29/38-05A 8311 Comanche Court  
MP Site #29/38 **Glenmore**

**MEMORANDUM**

SUBJECT: Historic Area Work Permit #378988

<b>Address:</b>	8311 Comanche Court, Bethesda	<b>Meeting Date:</b>	05/11/05
<b>Applicant:</b>	Nancy Everett and Mike Nannes	<b>Report Date:</b>	05/04/05
<b>Resource:</b>	<i>Master Plan</i> Site #29/38 <b>Glenmore</b>	<b>Public Notice:</b>	04/27/05
<b>Review:</b>	HAWP	<b>Tax Credit:</b>	Partial
<b>Case Number:</b>	29/38-05A	<b>Staff:</b>	Michele Oaks
<b>PROPOSAL:</b>	Rehabilitate and Replace Windows

# Glenmore - 2nd Floor (approximate)

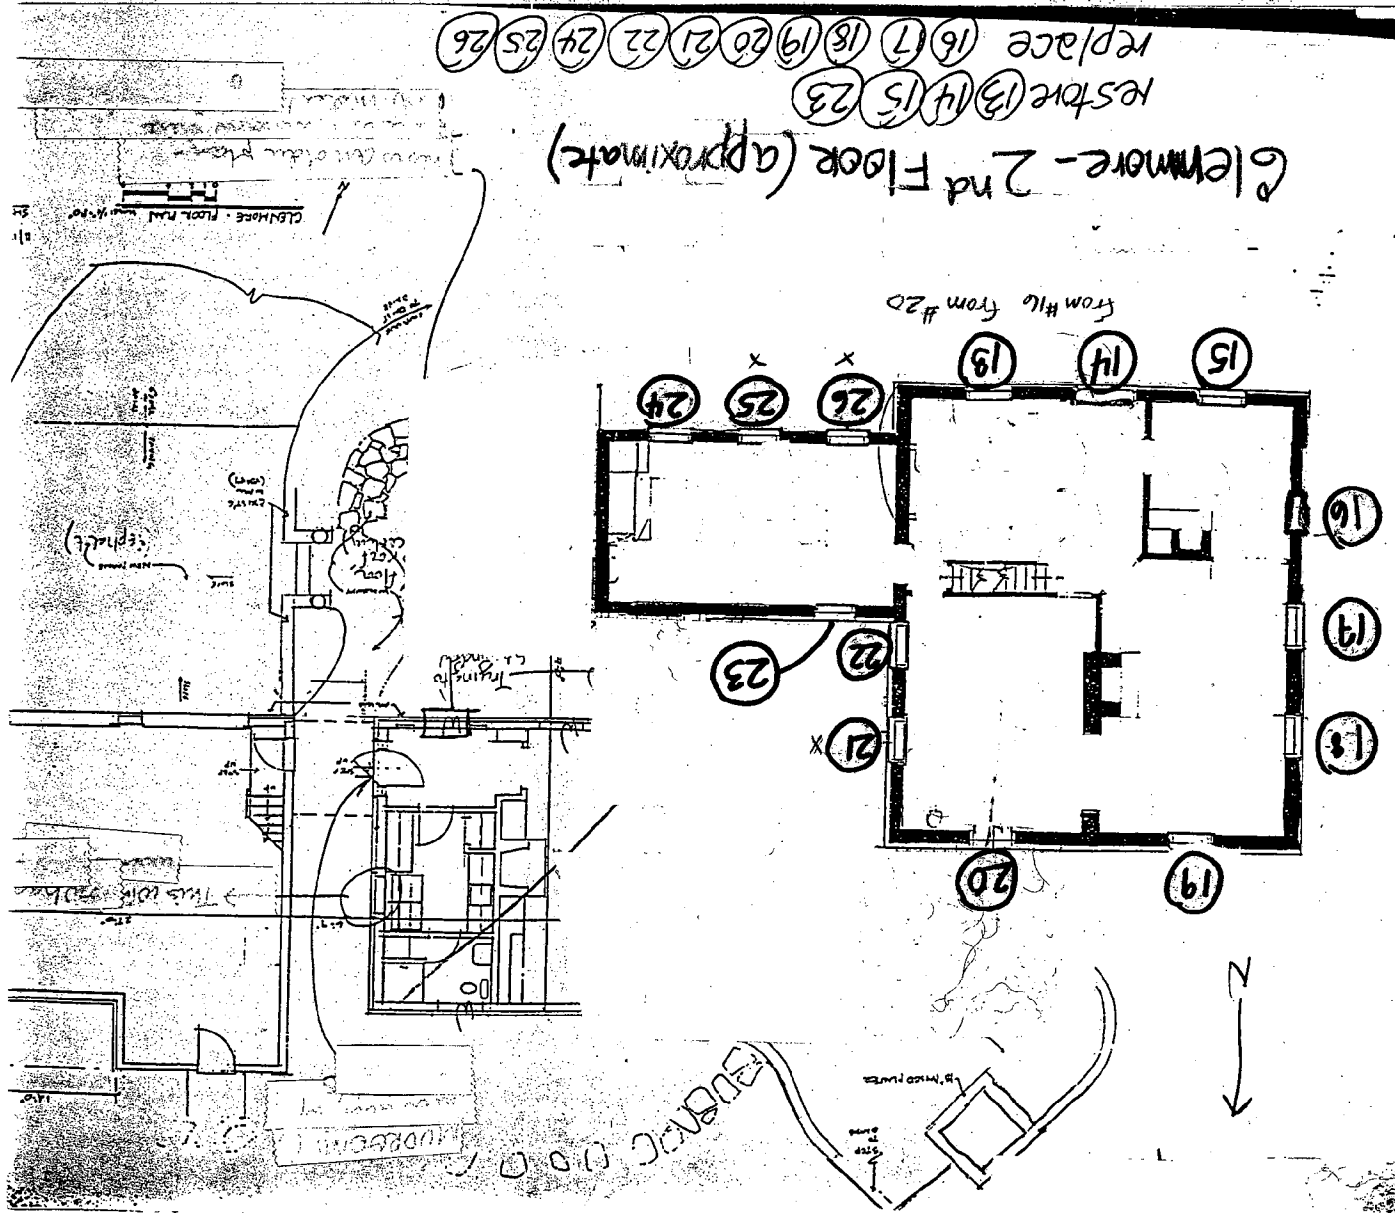
Restore (13, 14, 15, 23)

replace (16, 17, 18, 19, 20, 21, 22, 24, 25, 26)

1. The applicant will only be replacing the sashes and installing jamb liners on the subject 11 windows.
2. The existing frames on the subject windows will be repaired. Holistic replacement of the entire window frame is not approved.
3. The replacement window sashes will be simulated divided light, wood windows and will match the muntin profiles of existing window sashes.

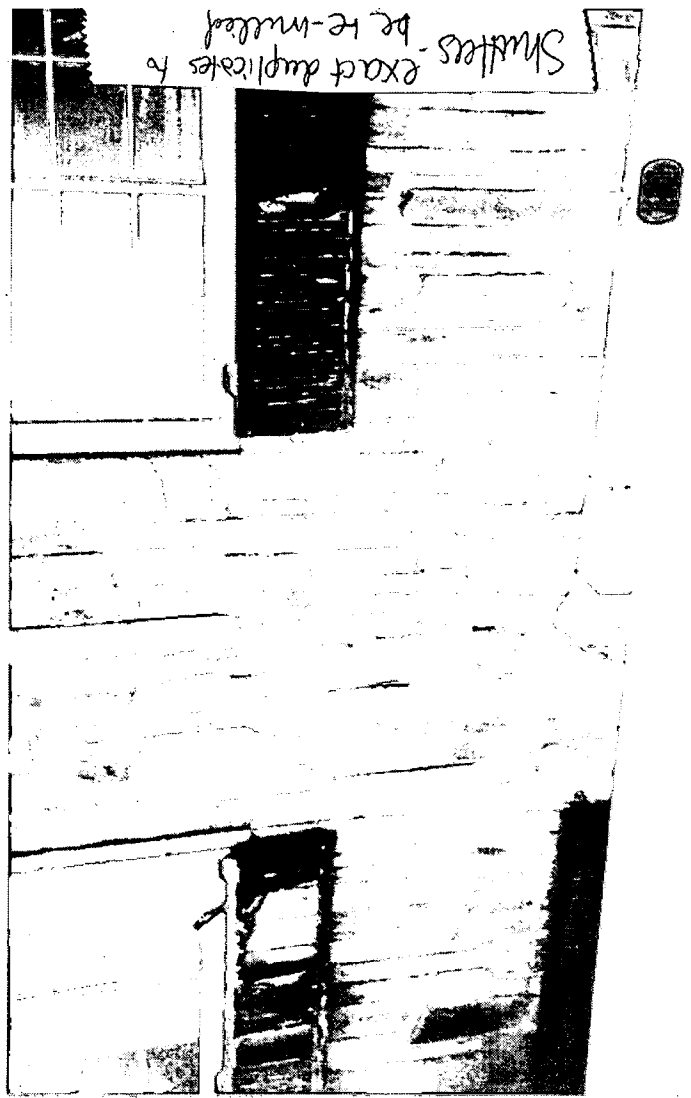
Rotten sill in downstairs window - to be restred

Damaged muntins + not on # 26 (replace

#19 - pieced; note uneven meeting  
boards (replace) + sides
